UNITED STATES PATENT AND TRADEMARK OFFICE

Office Action Summary

09/919,304

BENSON ET AL.

Fig. 1A

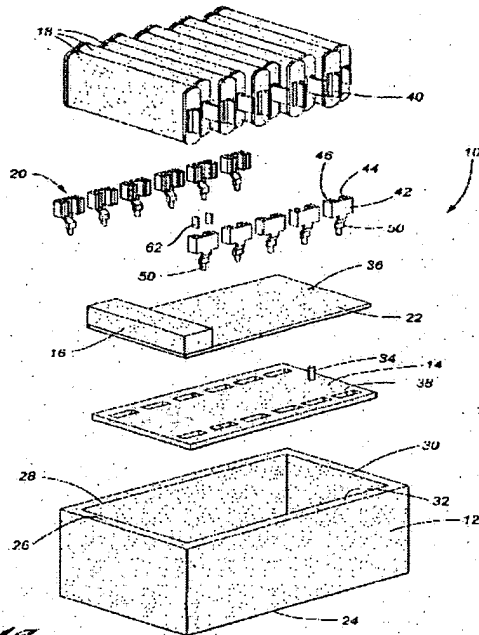
It is also disclosed that the flexible circuit performs current limiting functions (COL 2, lines 5-14. *Thus, it senses current, at least, to some extent.* It is also apparent from Figures 1A and 2 above, that the flexible printed circuit comprises flexible joints which allow the flexible printed circuit to have some move-ability.

Fig. 1C

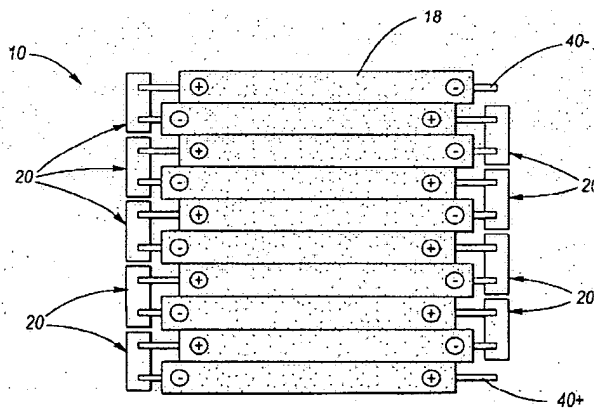
It is disclosed that the battery pack includes a plurality of buss interfaces 20 (COL 3, lines 10-13) having flange portions (col 3, lines 25-30) which connects the modules by edge

connections connecting positive and negative terminals of adjacent cells (COL 3, lines 55-64/
COL 3, line 65 to col 4, line 5/ Figure 1C).

Fig. 1D

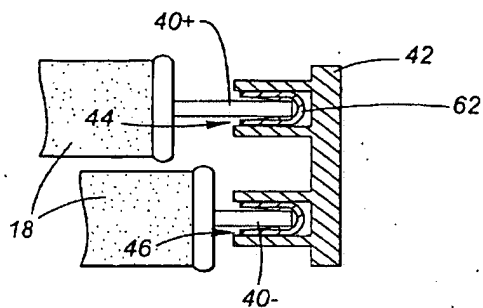
Figures 1D, 4A and 5 illustrate the connecting means including flat features and projecting members which are configured to be connected to the battery terminals and be accommodated through channels.

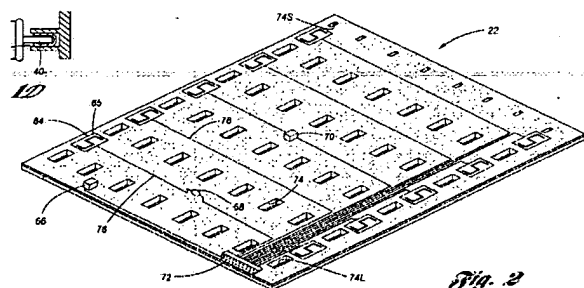
Figure 2 below illustrate a fuse 70 (COL 5, lines 24-30); a connector 72 to transmit electrical signals between circuit 22 and controller 16 (COL 5, lines 33-38); a resistor 68 provided to limit the current transmitted to controller 16 from buss blade 50 (COL 5, lines 15-23) *Thus, the resistor 68 acts as a current sensor.* It is also noted that connector 72 is used for voltage sensing (COL 5, lines 1-5). *Thus, voltage can be correlated to obtain the expected current magnitude.*
